PRODUCT CHANGE NOTICE

**Alternate Manufacturing Site
for Assembly of the Listed
Intersil QSOP and SC-70
Packaged Products**

**Refer to:
PCN12091**

Subject: **Alternate Manufacturing Site for Assembly of the Listed Intersil QSOP and SC-70 Packaged Products – Carsem, Ipoh Malaysia (CAM)**

PCN12091 – Current POD QSOP 16I and 24I

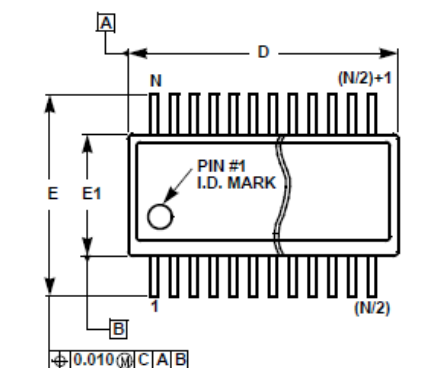
The Carsem (CAM) facility is ISO 9001:2008, TS 16949:2009, and ISO 14001:2004 certified. The CAM facility is qualified as a supplier to Intersil for performing assembly of packaged products, including the QSOP and SC-70 package styles. There will be no change in the die attach, bond wire (material or diameter), frame material, or moisture sensitivity level (MSL). The 16I QSOP, 24I QSOP, and select 6I SC-70 packaged devices will require minor dimension changes to the package outline drawings (POD). The affected PODs and a summary containing a list of products along with the current and new PODs are included for reference. The material set combinations for assembly and other key items are as follows:

Key Items	Unisem - Current		Carsem M - New (Alternate)	
	QSOP	SC - 70	QSOP	SC - 70
Mold Compound	SG600	SG600	SG600	CEL9220HF13
Die Attach	A8290	84-1LIMSR4 or A8006NS	A8290	84-1LIMSR4 or A8006NS
Bond Wire - Gold (Au)	1.0 or 2.0 mil	1.0 mil	1.0 or 2.0 mil	1.0 mil
Moisture Sensitivity Level	2 or 3	1, 2, or 3	2 or 3	1, 2, or 3
Frame Material	C194	C194	C194	C194
Device Marking - Site Code	B	B	F	F
